June 5, 2019

Addendum CC-02

Milford Public Schools
Jr-Sr High School Addn. & Renovation
301 G Street
Milford, NE 68405

addendum no. 02

1 E2.1
FIRST FLOOR PLAN - POWER
NOT TO SCALE

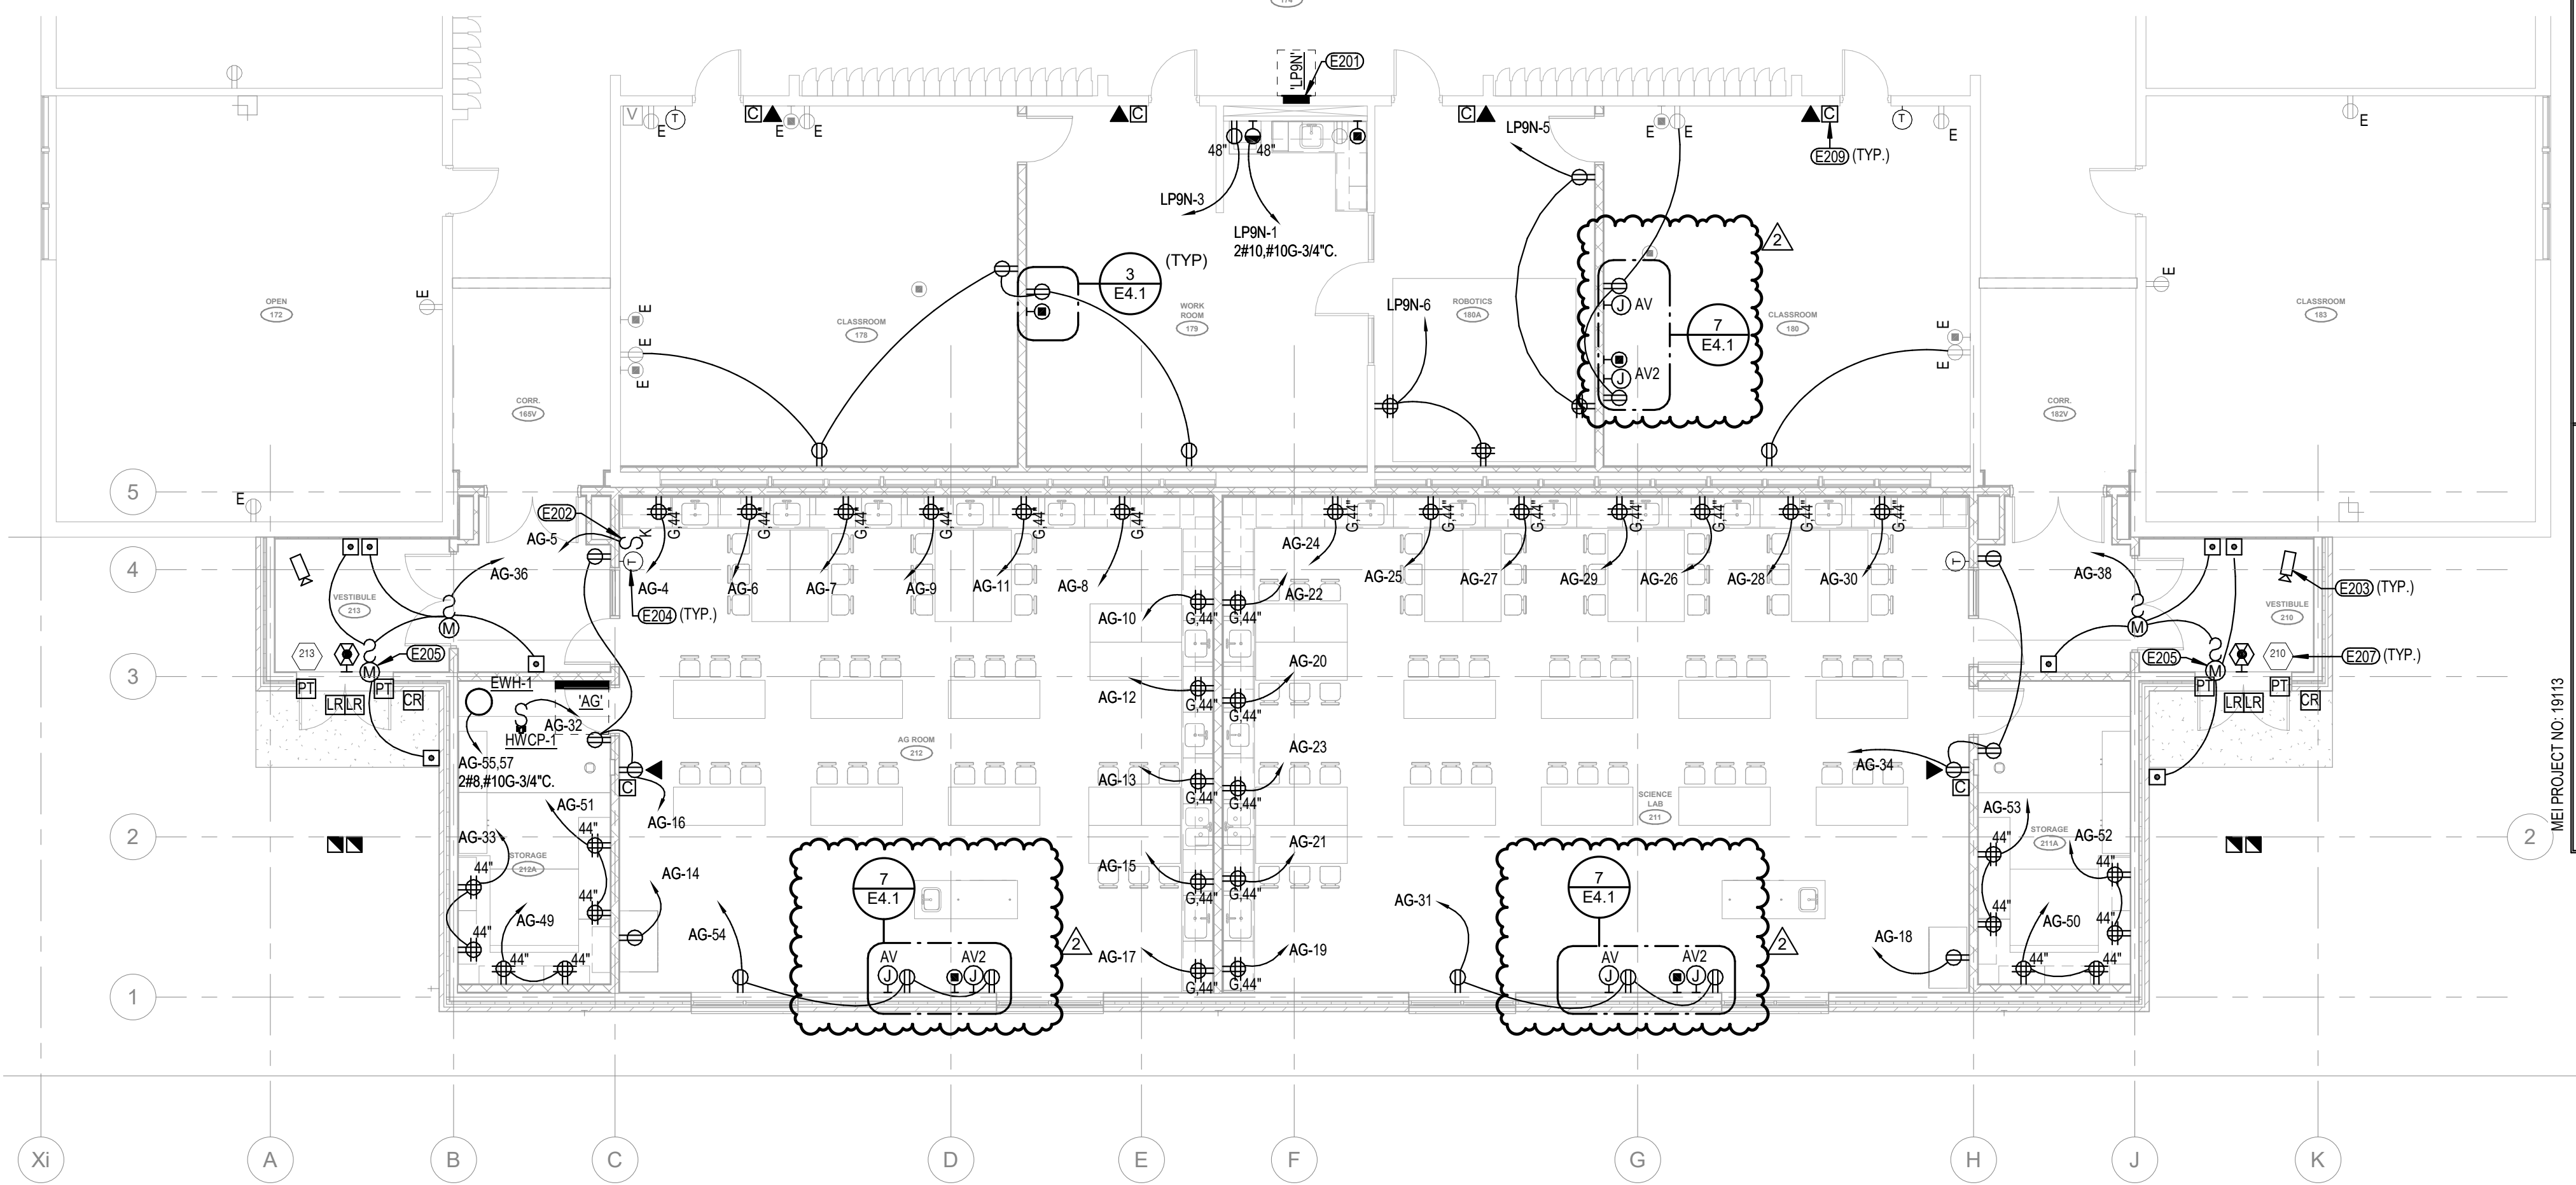
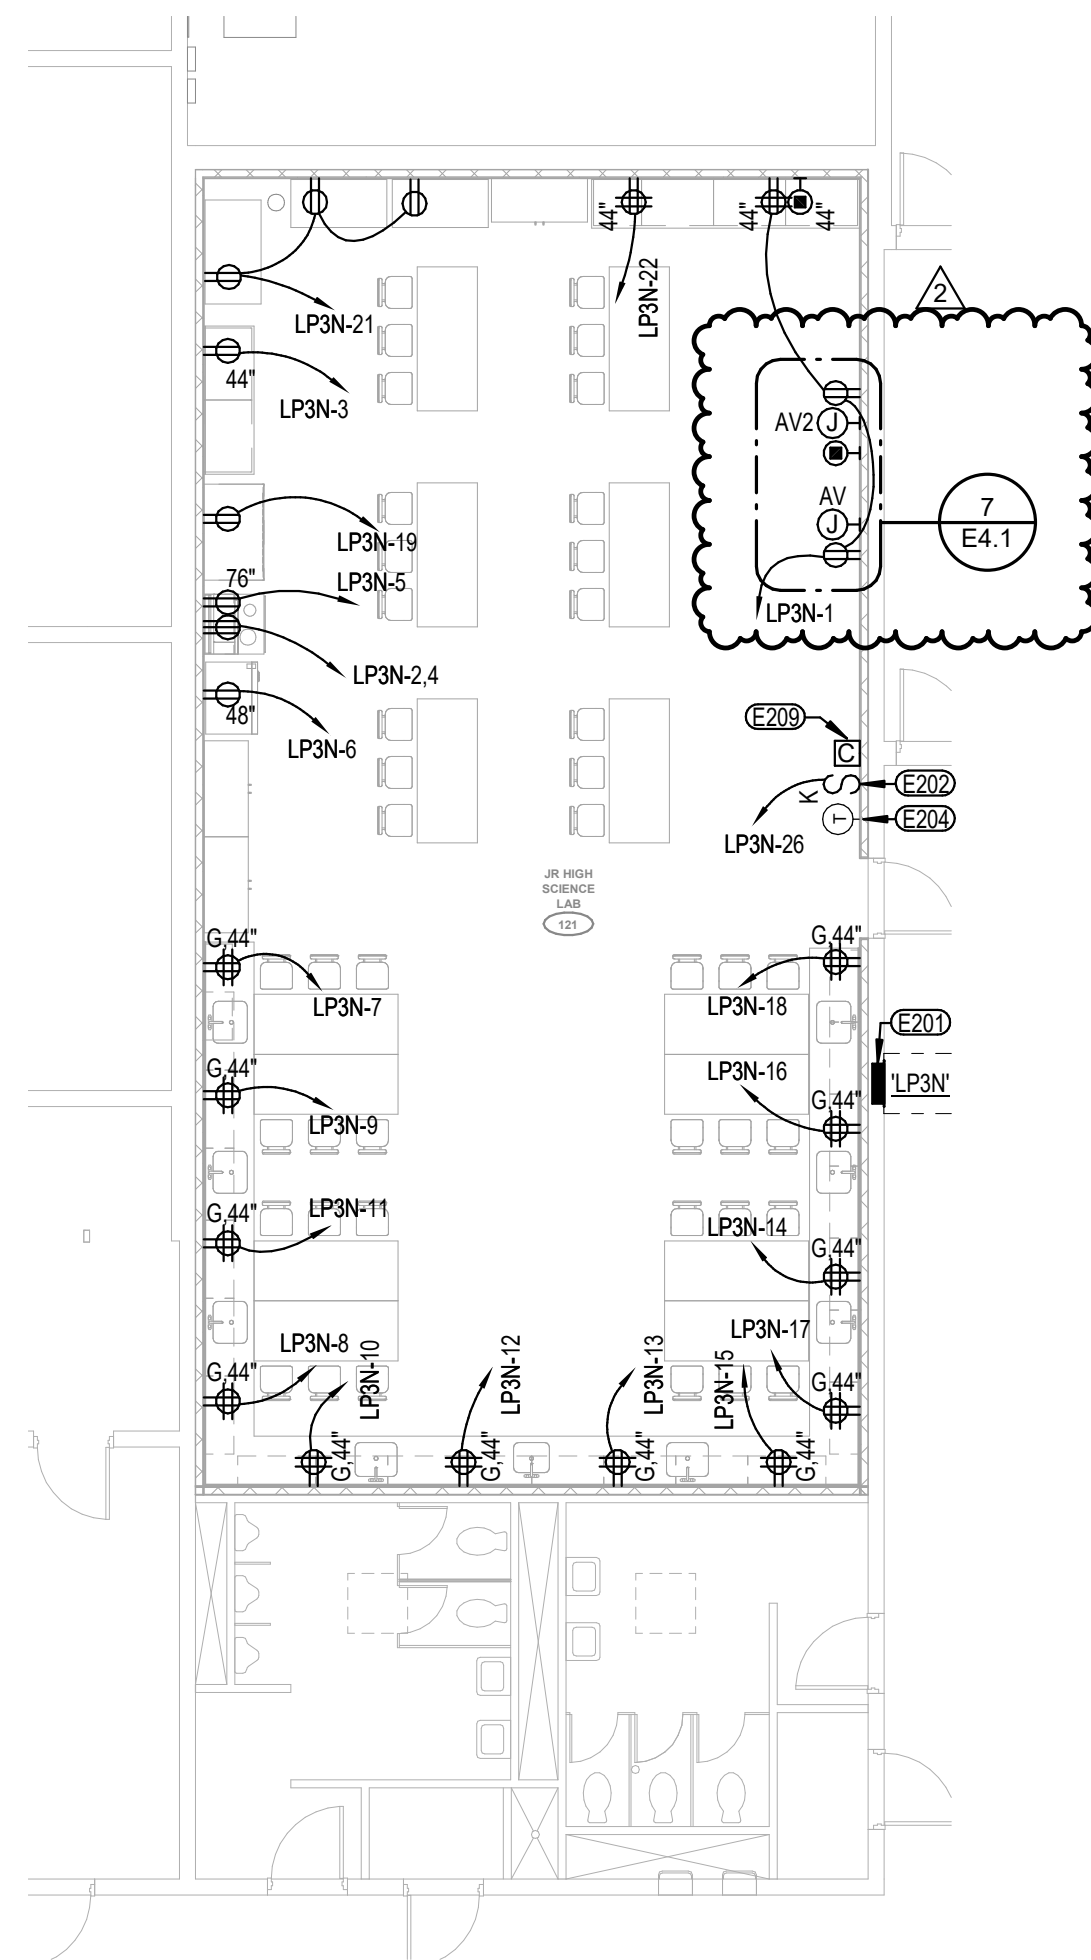
1. Section 268100.1.4.A.1
 - a. Shall read: "Interface with existing fire alarm system. Existing system is **Siemens.**"
2. Sheet E2.1 – Floor Plan - Power
 - a. Revise power, data and AV rough-in locations in Classrooms 121, 180, 211, and 212.
 - b. Remove receptacles below junction box 'AV' in Classrooms 121, 180, 211, and 212.
 - c. See attached revised sheet.
3. Sheet E3.1 – Floor Plan – Special Systems
 - a. Revise data and AV locations in Classrooms 121, 180, 211, and 212.
 - b. See attached revised sheet.
4. Sheet E4.1 – Electrical Details
 - a. Revise detail 7.
 - b. See attached revised sheet.
5. Sheet E5.1 – Luminaire Schedule
 - a. The following manufacturers have been approved for the light fixture types listed below. All items are subject for review during shop drawing submittal.

SCIENCE LAB - AG ROOM CODE PLAN
1/8" = 1'-0"

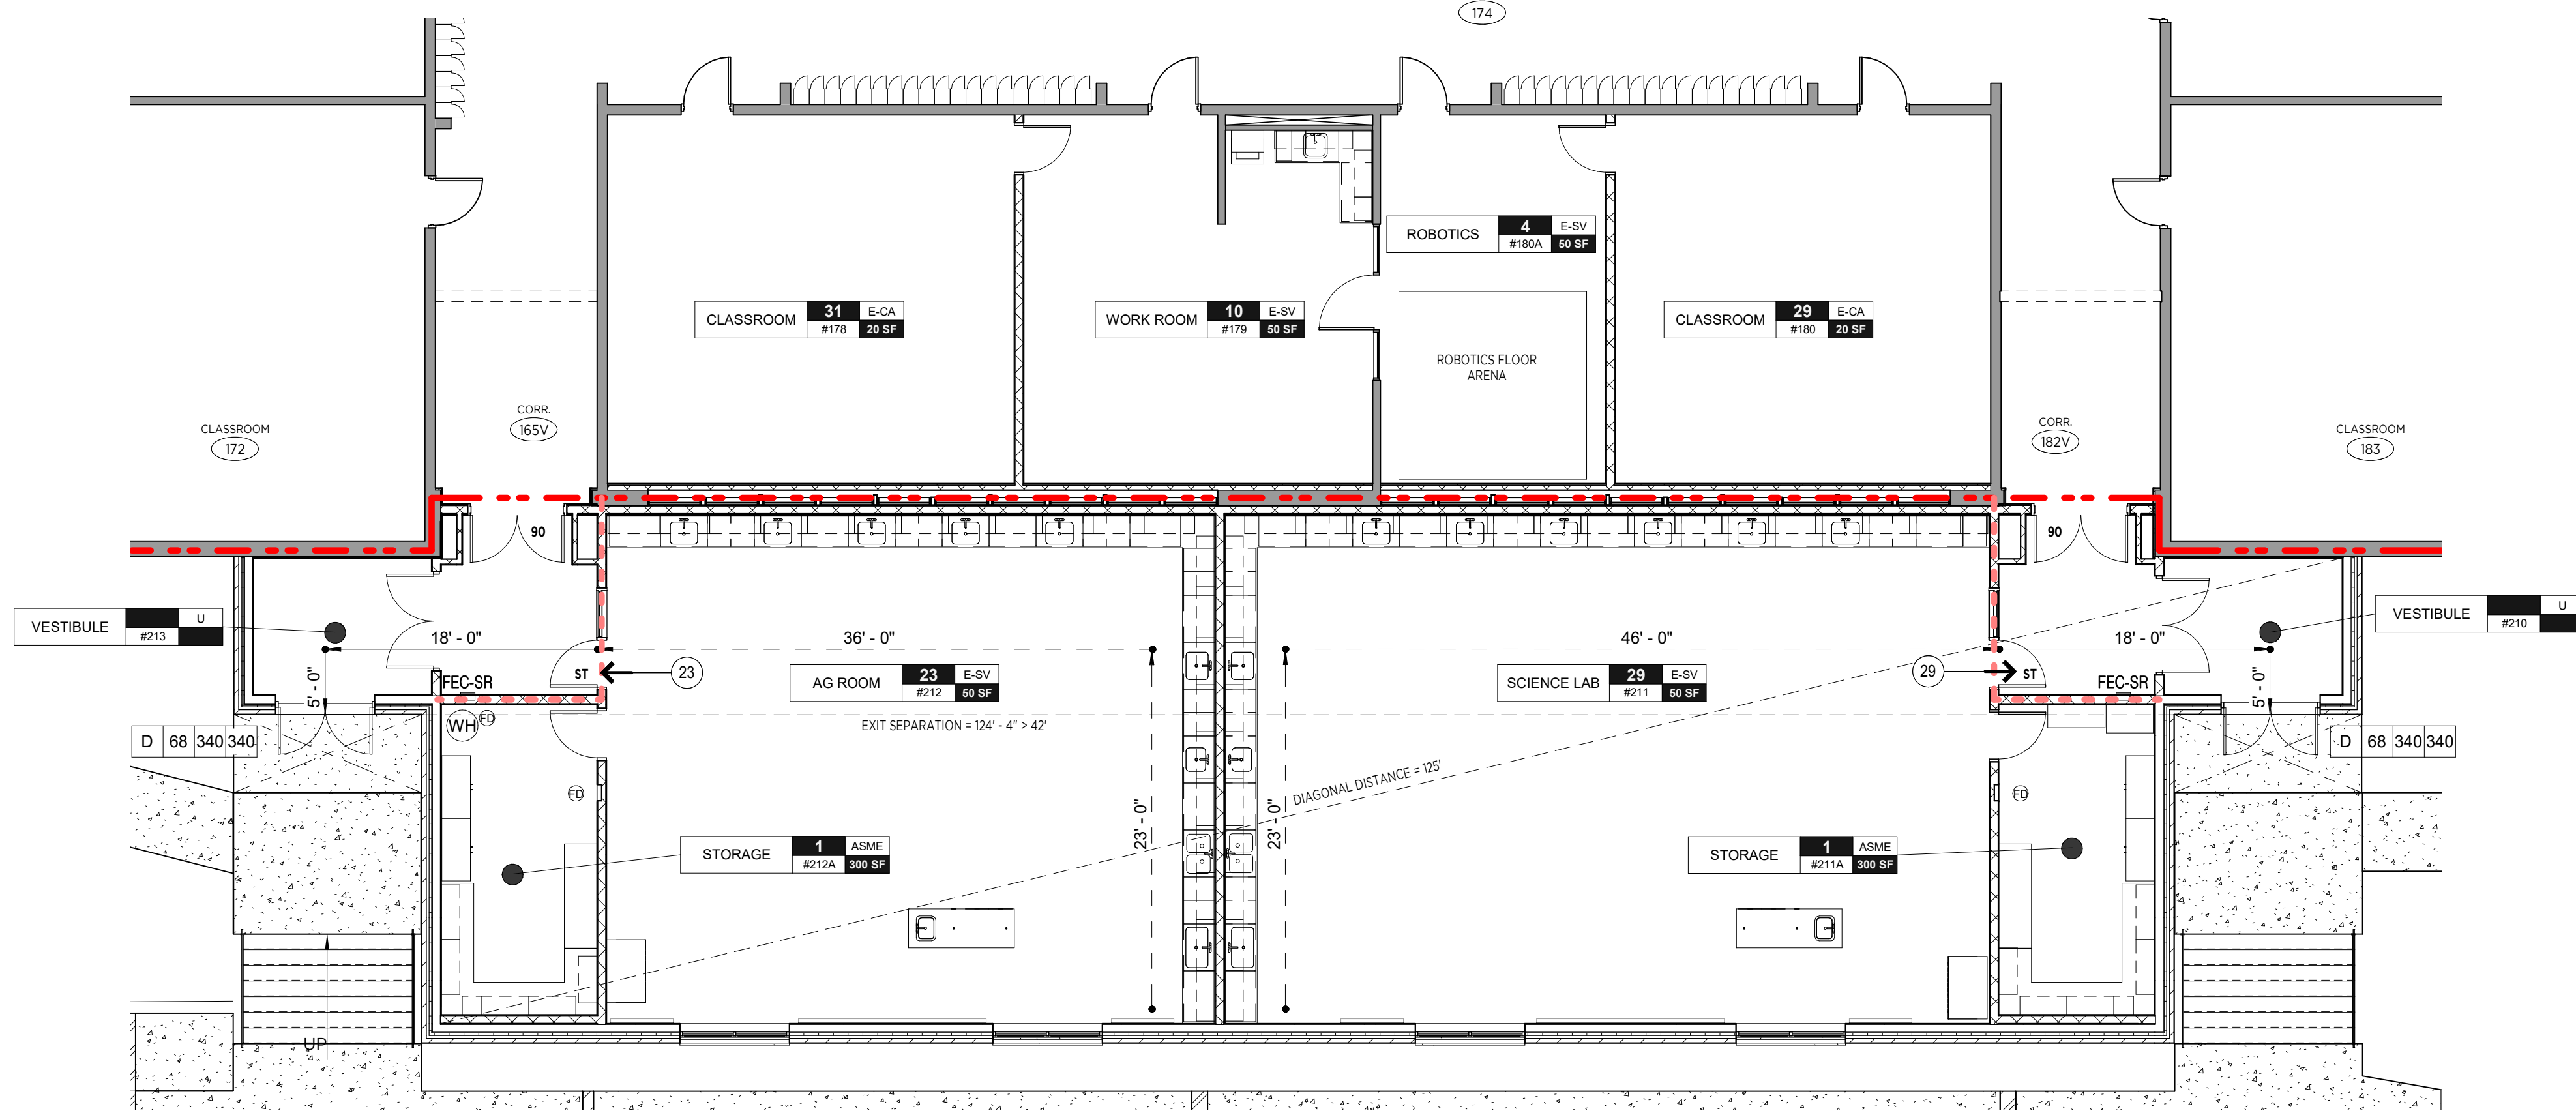
- A. There was a TYPO on the Applicable Codes. This Sheet has been Revised & Re-Issued to change the following:
1. Delete 2009 IMC and Replace with 2012 IMC
 2. Delete 2009 IPC and Replace with 2012 IPC
- B. Design Hazard for the Science Lab Criteria has been added to this sheet. This sheet has been Revised & Re-Issued per this addendum.

SCHOOL SCIENCE ROOMS & LABS:

IN ACCORDANCE TO NFPA 1 CHAPTER 60, A SCHOOL LABORATORY AND ASSOCIATED STORAGE ROOM WILL NOT BE CONSIDERED A HIGH HAZARD AND WILL ONLY BE REQUIRED TO MEET NORMAL HAZARDOUS AREA REQUIREMENTS (I.E. SEPARATION OR FIRE SPRINKLER PROTECTION) WHEN THE FOLLOWING ARE MET:

- FLAMMABLE LIQUID STORAGE AND USE IS LIMITED TO NOT MORE THAN 30 GALLONS TOTAL PER TABLE 60.2.2.1A.
- FLAMMABLE GAS USE IS LIMITED TO NOT MORE THAN 1000 CUBIC FEET OF GAS TOTAL PER TABLE 60.2.2.1A.
- MATERIAL SAFETY DATA SHEETS (MSDS) FOR ALL HAZARDOUS MATERIALS SHALL BE READILY AVAILABLE AT THE PREMISES PER 60.1.8.3.
- A HAZARDOUS MATERIALS MANAGEMENT PLAN AND HAZARDOUS MATERIALS INVENTORY STATEMENT SHALL BE GENERATED. THEY SHALL CONSIST OF THE FOLLOWING:
 - AN EMERGENCY RESPONSE TRAINING PLAN AND A FACILITY SITE PLAN DESIGNATING THE FOLLOWING:
 - STORAGE AND USE AREAS.
 - MAXIMUM AMOUNT OF EACH MATERIAL STORED OR USED IN EACH AREA.
 - RANGE OF CONTAINER SIZES.
 - PRODUCT CONVEYING PIPING CONTAINING LIQUIDS OR GASES, OTHER THAN UTILITY OWNED FUEL GAS LINES AND LOW PRESSURE GAS LINES.
 - LOCATIONS OF EMERGENCY ISOLATION AND MITIGATION VALVES AND DEVICES PER 60.1.8.1 & 60.1.8.2.
